Comments on the Feasibility Study
Prepared by Geo-Hydro Inc. on behalf of
People in Need of Environmental Safety
December 26, 2012

Geo-Hydro Inc. (GHI) is submitting the following comments on the Feasibility Study (FS) for the Pines Area of Investigation dated November 2012, on behalf of People In Need of Environmental Safety (PINES). Our general and specific comments on that document are provided below. Additional comments on the radiological characterization of CCBs in the study area provided by Mr. Larry Jensen, a Health Physicist and member of PINES, are provided in the Appendix. The comments identify the most significant technical issues associated with the FS. GHI and Mr. Jensen will address issues with the FS and prior documents with PINES as the Remedial Investigation/Feasibility Study (RI/FS) process continues and concludes, thereby allowing PINES to fulfill its obligations to the public under the TAP.

Comments on

Pines FS_Figures_November 29_2012

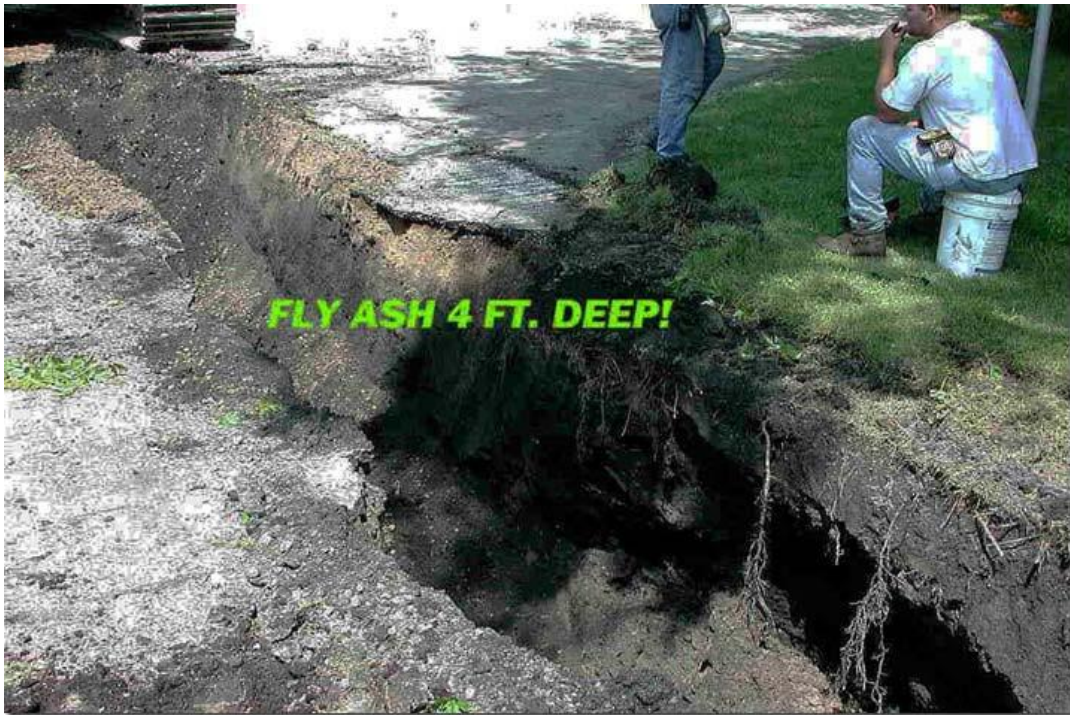
CCB's appear to be present in subsurface soils, perhaps extensively. A citizen of Pines took the following picture during road work that shows a seam of material, potentially bottom ash, approximately 4 feet thick. Remediation actions must be cognizant of this potential.
